Subject: Offsite Monitoring Well Installation
3635 13th Avenue
Oakland, California
AEI Project No. 270852

Subject: Fuel Leak Case Number [REDACTED] Mobil, 3635 13th Avenue, Oakland, CA – Work Plan Approval

Subject: Phase II Subsurface Investigation Workplan
3635 13th Avenue
Oakland, California
Project No. 1610
STID 1121

ALL ENVIRONMENTAL, INC.		
2641 CROW CANYON RD, SAN RAMON		
SCALE: 1" = 16'	APPROVED BY:	DRAWN BY: S.P.
DATE: 3/8/94		REVISED: S.P.
BORING AND WELL LOCATION MAP		
3635 13TH. AVENUE		DRAWING NUMBER: FIGURE 3

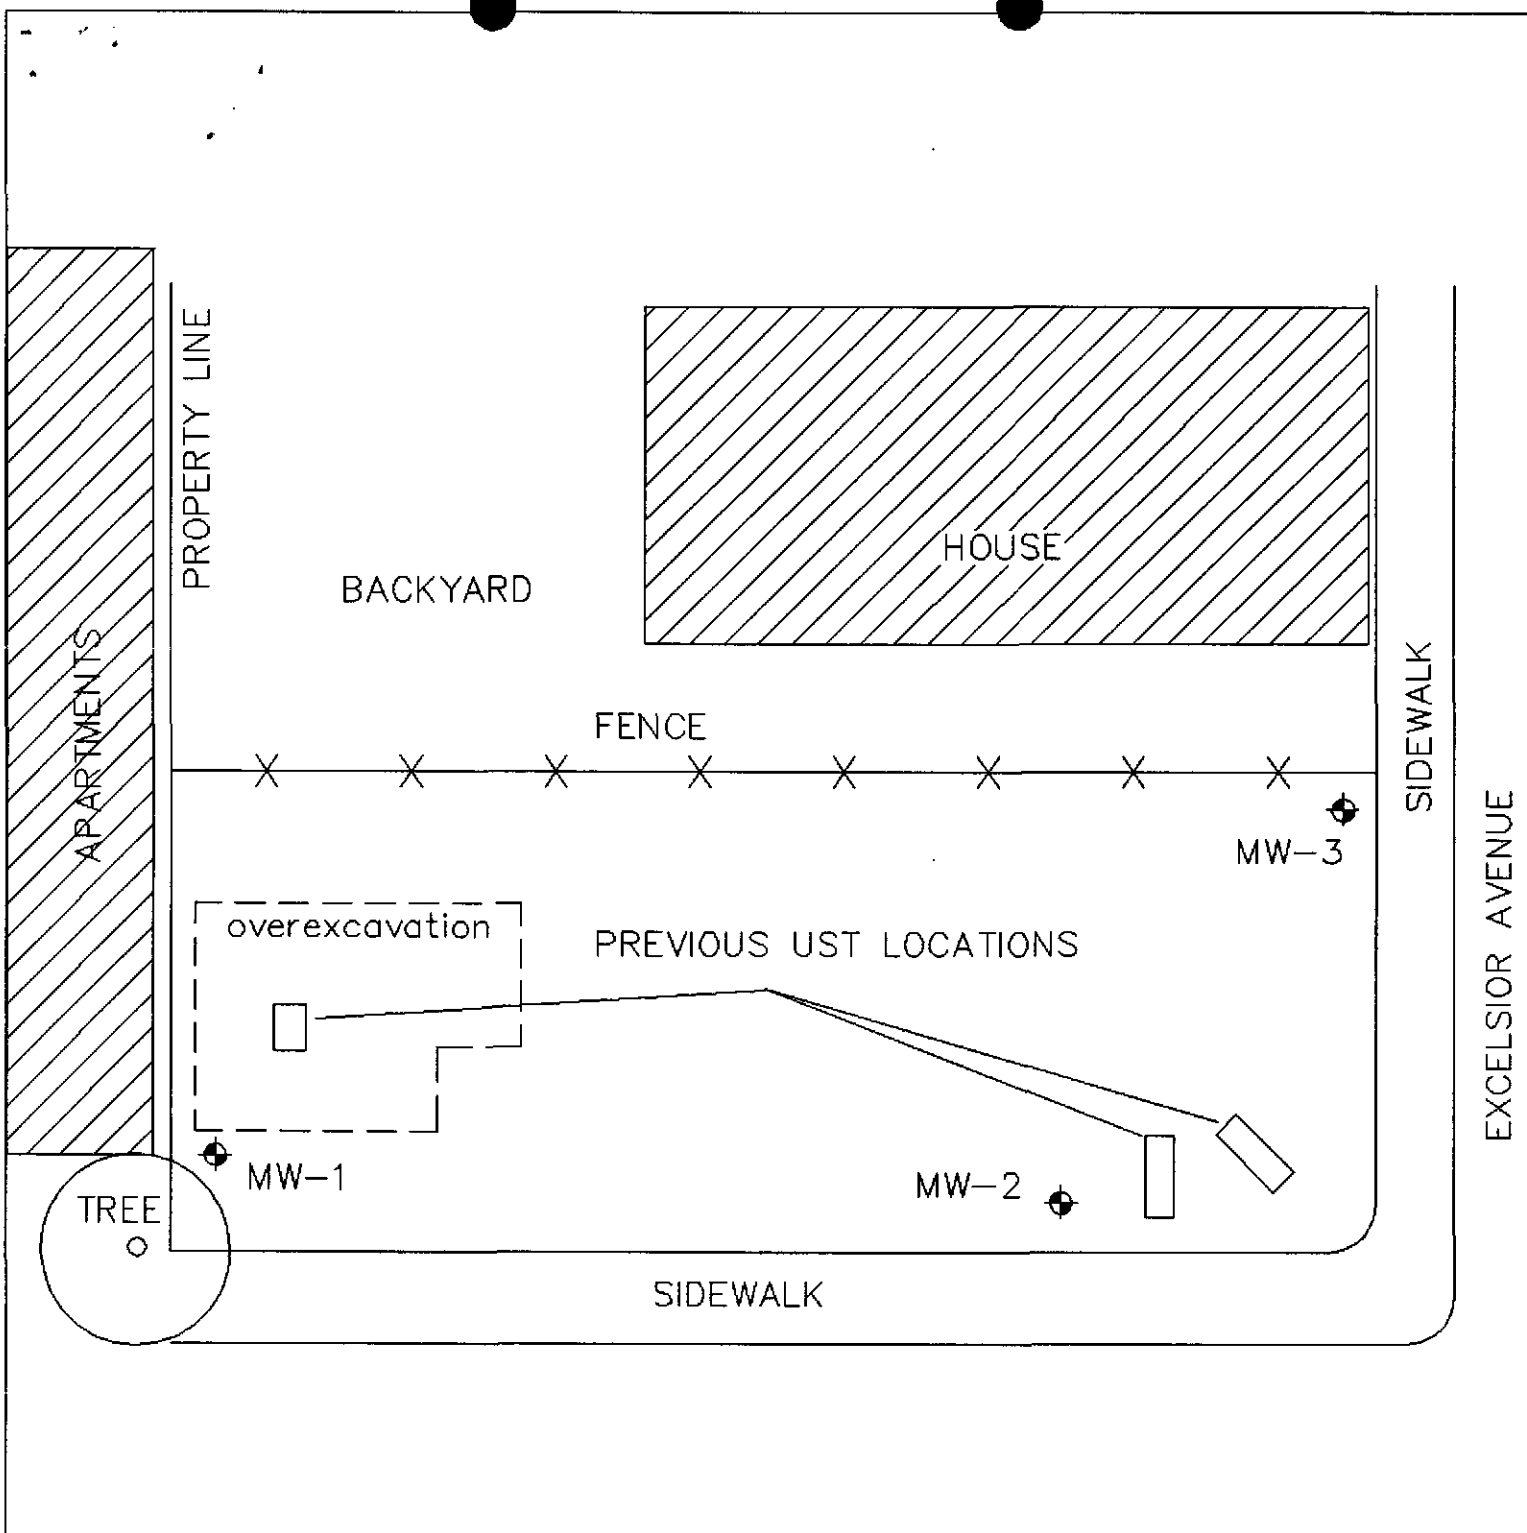
Enclosed is a revised soil boring and well location map, for the Soil Boring and Monitoring Well Installation Work Plan dated December 9, 1993, as you requested. The map has been set to a scale of one inch to sixteen feet, and minor changes have been made to the configuration of the wells.
